<b>STAFF REPORT</b>	
<b>COMMUNITY DEVELOPMENT DEPARTMENT</b>

HEARING DATE: March 21, 2023  
 TO: Mayor & City Council  
 FROM: Sonya Allen, Associate Planner  
 208-884-5533  
 SUBJECT: Millwood Subdivision  
 H-2022-0089  
 LOCATION: 1975 E. Victory Rd., in the NW 1/4 of  
 Section 29, T.3N., R.1E. (Parcel  
 #S1129223095)

Annexation of 4.74 acres of land with an R-8 zoning district; and preliminary plat consisting of 17 building lots (including one for an existing home) and two (2) common lots on 4.11 acres of land in the R-8 zoning district for Millwood Subdivision.

### B. Preliminary Plat (dated: 2/10/23)

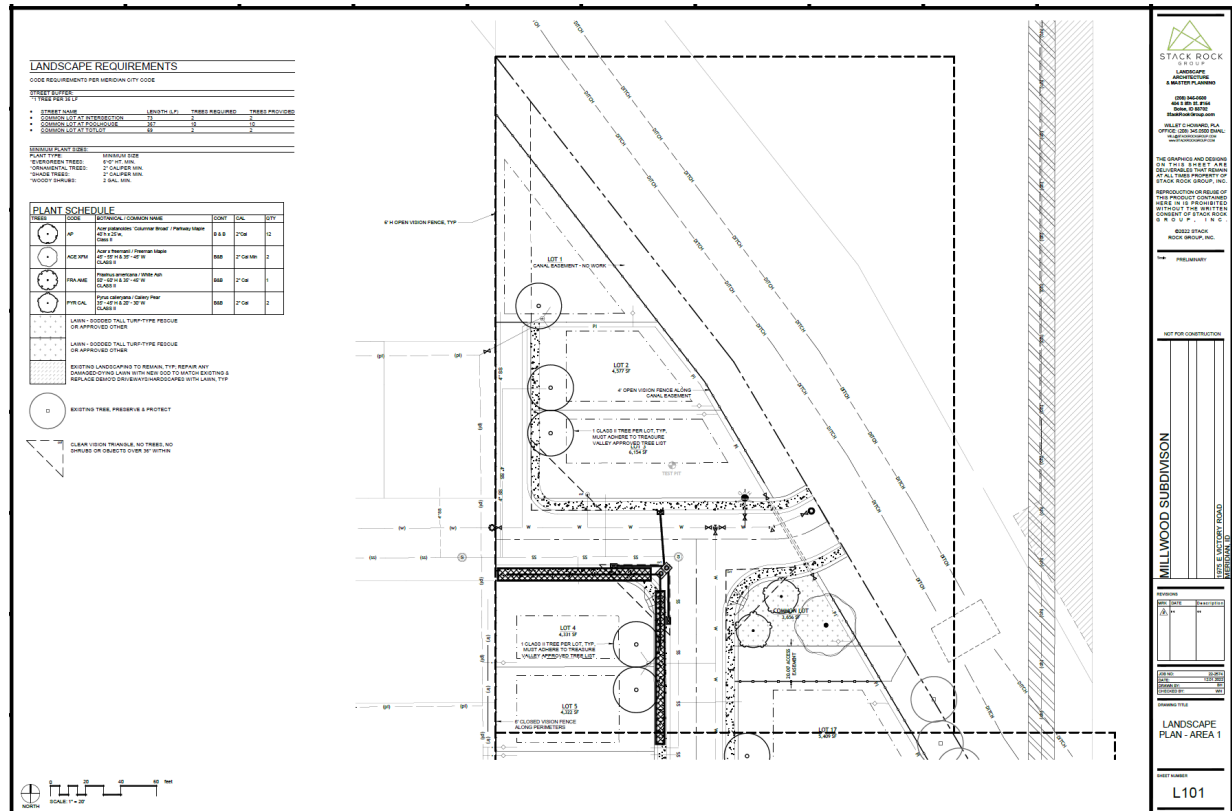
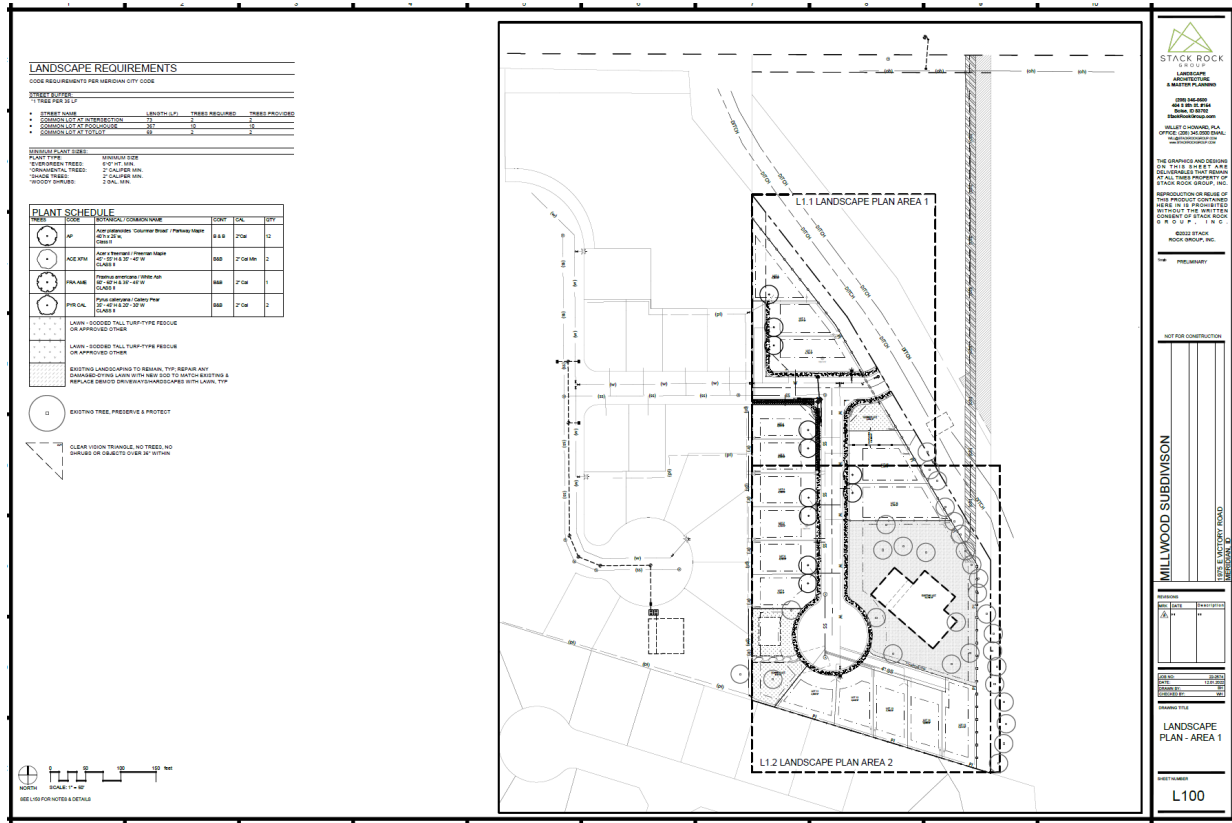
**Dimensional Standards (UDC [11-2](#)):** The proposed plat and subsequent development is required to comply with the dimensional standards listed in UDC [Table 11-2A-6](#) for the R-8 zoning district. **The proposed plat appears to comply with the dimensional standards of the district although a curve table was not included on the plat to ensure compliance. Lot numbers in each block should be consecutive; revise accordingly.**

**The access for the existing home via an easement from Victory Rd. shall terminate and sole access should be provided internally from Tamayo Ct.; emergency access only may be provided from this driveway. The address for the existing home is required to change since access will no longer be provided via Victory Rd.**

**Sidewalks ([11-3A-17](#)):** A 5-foot wide attached sidewalk is required along internal local streets as proposed. **Sidewalks and curbing are not required along common driveways; remove from the plan.**

- c. Remove the sidewalks and curbing along common driveways.
    - d. Include a curve table.
    - e. Revise lot numbers in each block to be consecutive.

- f. Remove the common lot for the pathway along the eastern boundary of this site south of the existing bridge as the pathway is planned to cross the bridge and continue off-site to the south. This area can be absorbed by adjacent lots.

- g. Amend the plat consistent with the lot configurations depicted on the revised common driveway exhibit in Section VIII.D.
  3. The landscape plan submitted with the final plat shall include the following revisions:

## D. Common Driveway Exhibit

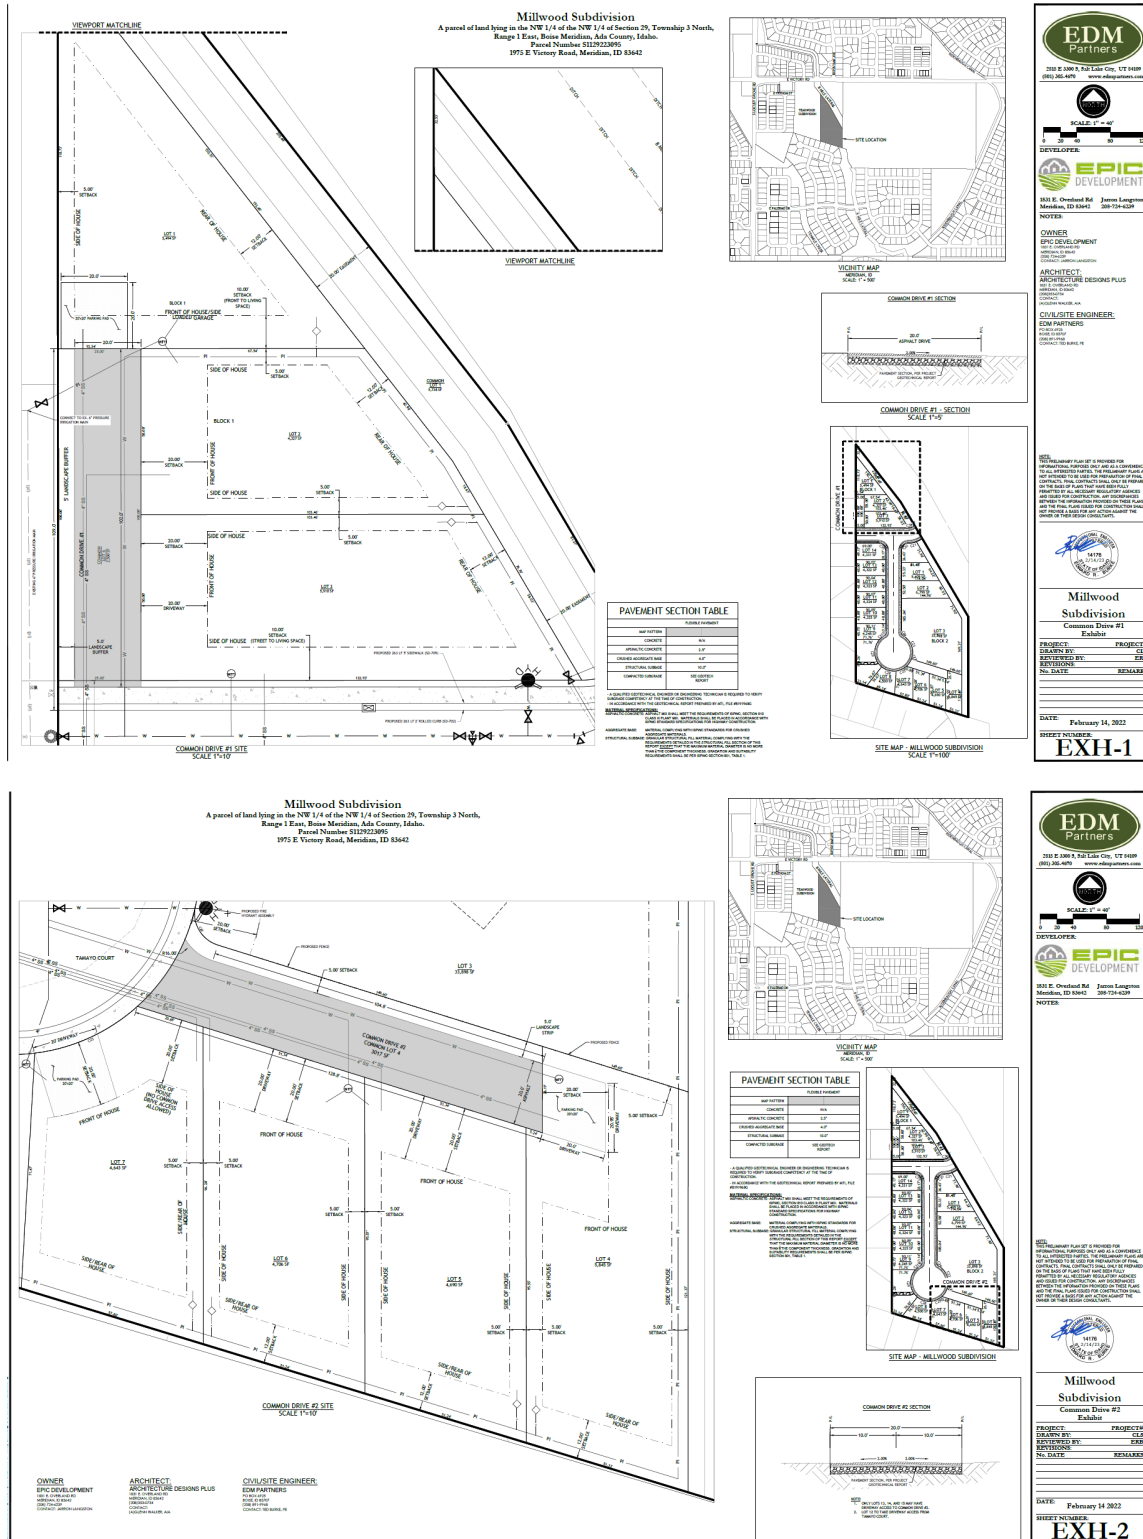
**Common Driveways (UDC [11-6C-3D](#)):** All common driveways are required to be designed and constructed per the standards listed in UDC 11-6C-3D. Two (2) common driveways are proposed on the plat.

All properties that abut a common driveway shall take access from the driveway; however, if an abutting property (i.e. Lot 12) has the required minimum street frontage, that property is not required to take access from the common driveway. In this situation, the abutting property's driveway shall be on the opposite side of the shared property line; away from the common driveway. Solid fencing adjacent to common driveways shall be prohibited, unless separated by a minimum five-foot wide landscaped buffer planted with shrubs, lawn or other vegetative groundcover. ~~A revised detail for the common driveways should be submitted that depicts the setbacks, fencing, building envelope (including parking pad), landscaping and orientation of the lots and structures.~~

A perpetual ingress/egress easement shall be filed with the Ada County Recorder, which shall include a requirement for maintenance of a paved surface capable of supporting fire vehicles and equipment. The easement may be depicted on the plat with a note including the required specifications or in a separate easement. **If a separate easement is submitted, a copy of the recorded easement shall be submitted prior to City Engineer signature on the final plat.**

9. All common driveways shall be designed and constructed per the standards listed in UDC [11-6C-3D](#) and shall be consistent with the exhibit in Section VIII.D. ~~Submit a detail for each of the common driveways with the final plat application that depicts the setbacks, fencing, building envelope (including parking pad), landscaping and orientation of the lots and structures that complies with the aforementioned standards. Make any changes necessary to the preliminary plat and landscape plan to comply with these standards.~~
